RE-EVALUATION FORM

A. Re-evaluation Type(s): Design Change

Project Name: I275 (SR93) FROM 54TH AVE S TO N OF 4TH ST NORTH

FAP Number	FM Number	Project/ Segment Name	Project/ Segment Location	Type(s)				Project/ Segment Letting Type	Funding
				PE	DC	ROW	CON		
D722-016-B	449109-2-32-01	I-275 (SR 93) FROM N OF I- 375 TO N OF 38TH AVE N	District 7 - PINELLAS	☐	☒	☐	☐	Design-Bid-Build	Federal

Figure 2 Pond Comparison Exhibit

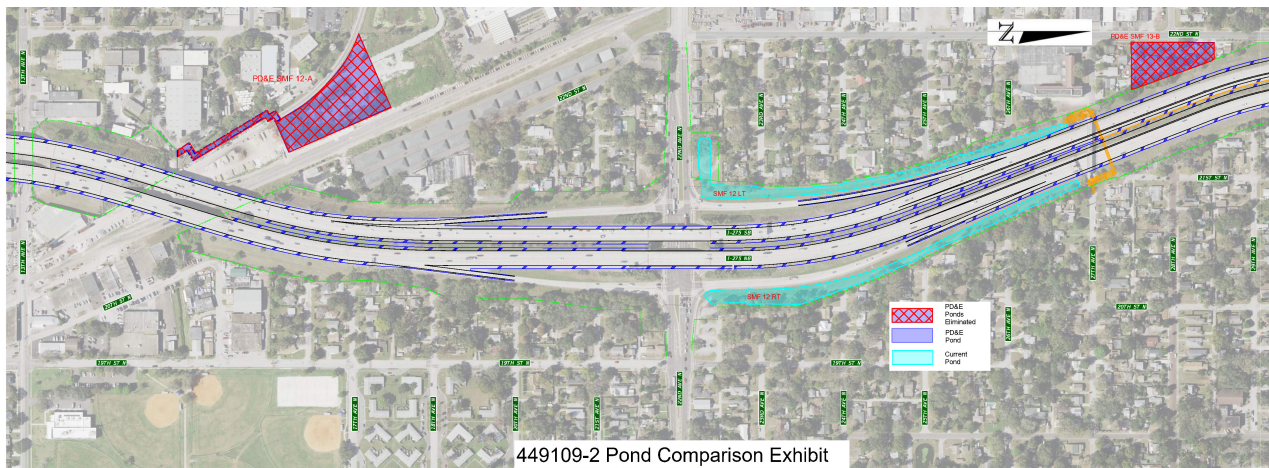
The previously approved offsite SMFs 12A and 13B are being eliminated and replaced with SMF 12 LT and SMF 12 RT which are proposed within the existing ROW (see Figure 2).

Figure 3 5th Avenue North Operational Improvements

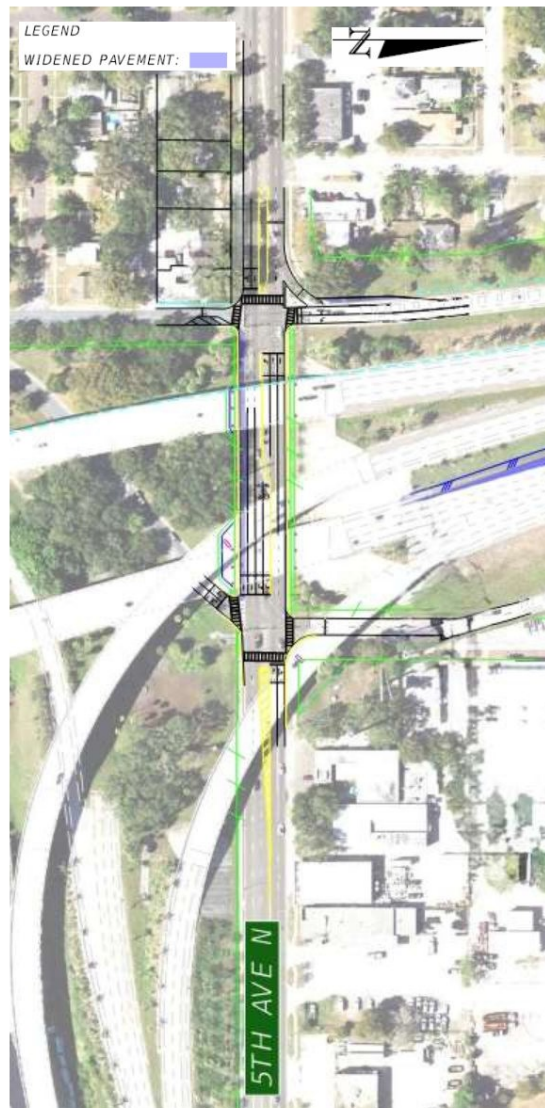
The improvements at 5th Avenue North include widening to the north and south along 5th Ave North to accommodate the EB 5th Ave North to NB I-275 left turn lane and widening on the west side of the SB I-275 exit ramp to accommodate a right turn lane from SB I-275 to WB 5th Ave North, see Figure 3.

Figure 4 22nd Avenue North Operational Improvements

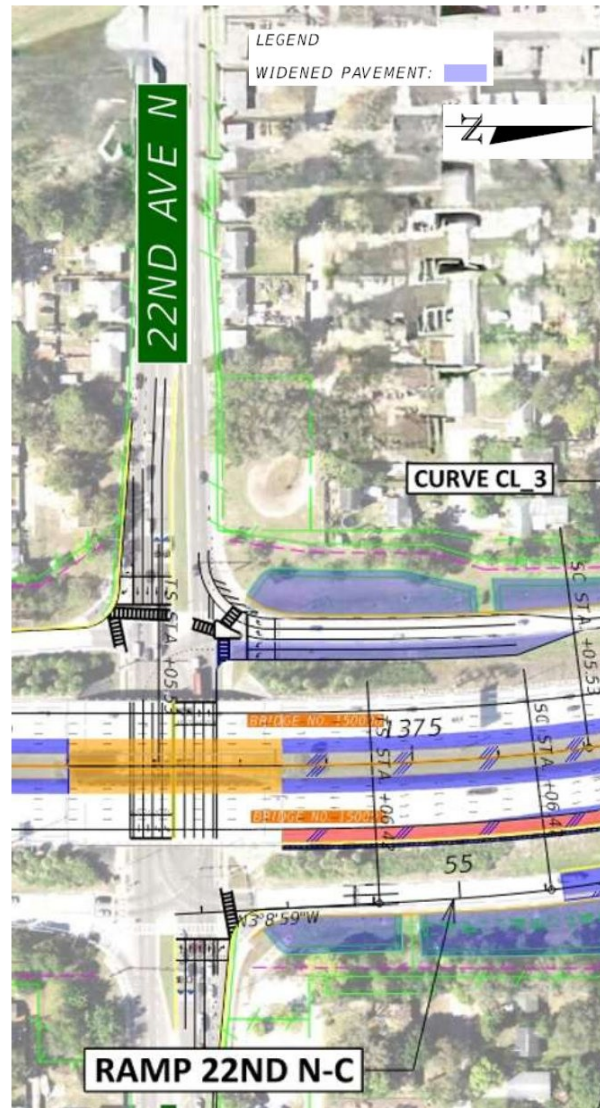
The improvements at 22nd Avenue North include widening on the east side of the SB I-275 exit ramp to accommodate an additional left turn and an additional right turn lane. The final proposed configuration includes two right turn lanes from I-275 SB to WB 22nd Avenue North and two left turn lanes from I-275 SB to EB 22nd Avenue North, seen below in Figure 4.

Figure 6 CSX ROW Exhibit

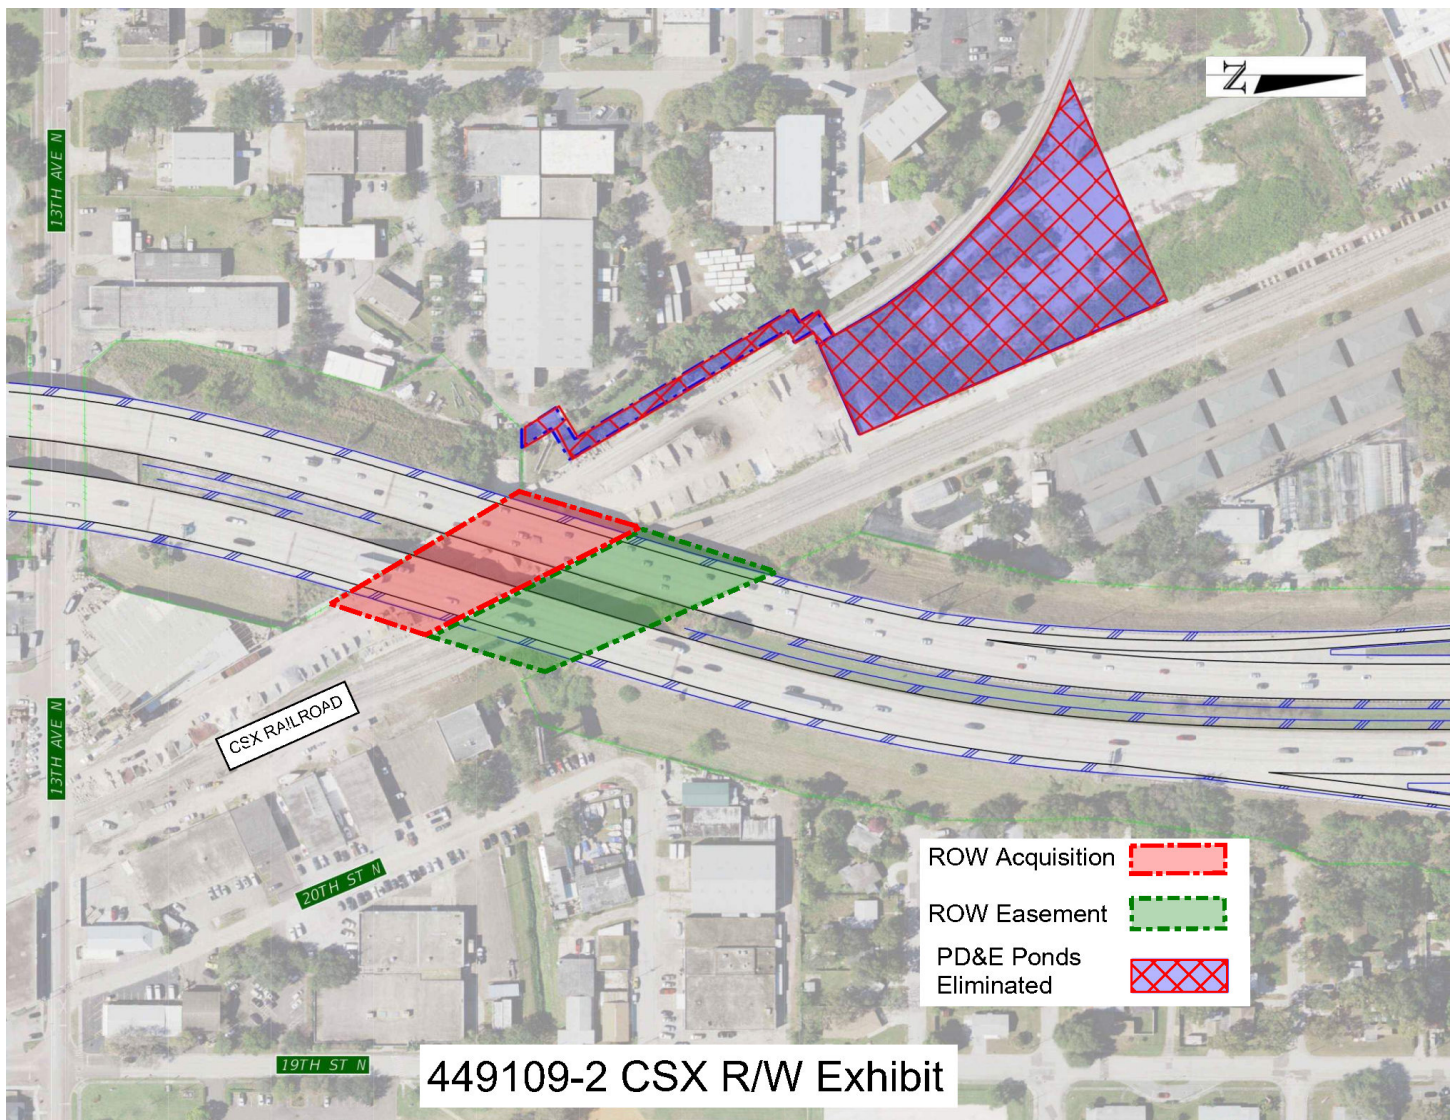
During the ROW acquisition phase, it was discovered that no easement exists between FDOT and CSX for the existing Interstate, I-275 over CSX property. In coordination with CSX and ROW, it was further discovered that CSX sold a portion of their property to a third party, Shore Line Holdings. FDOT is in the process of acquiring this private property to continue to allow I-275 to operate in this area. See Figure 6 below showing the proposed ROW acquisition and proposed easement.
